TEMPORARY ABANDONMENT WELL APPLICATION

Re: Temporary Abandonment  
API 15-015-19612-00-00  
WILSON A 227  
NE/4 Sec.08-25S-05E  
Butler County, Kansas

Your application for Temporary Abandonment (TA) for the above-listed well is denied for the following reasons(s):

**Analysis Method: Acoustic Velocity**

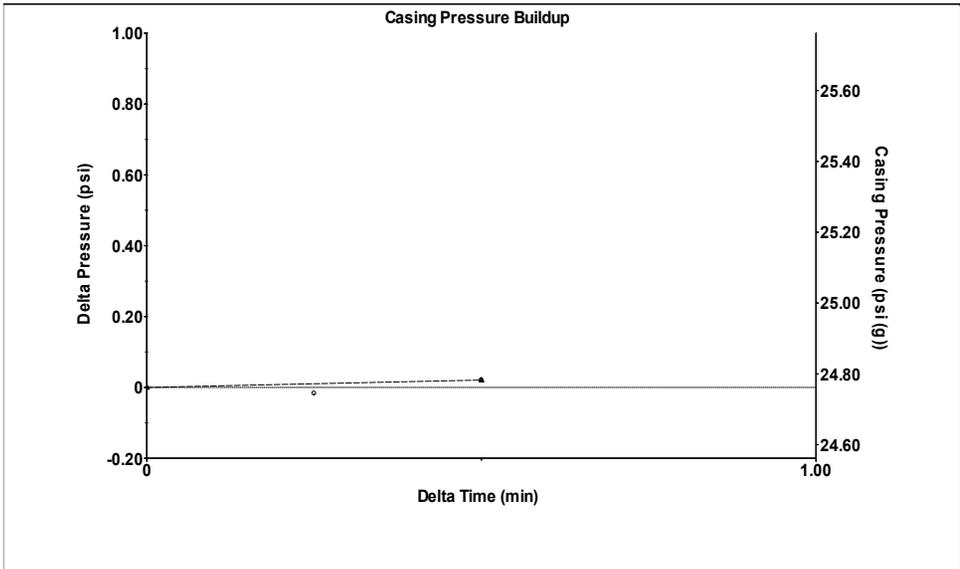
**High Fluid Level  
Well will need to pass CIT for TA purposes.**

Pursuant to K.A.R. 82-3-111, the well must be plugged, or returned to service, or obtain temporary abandonment status by 12/04/2025.
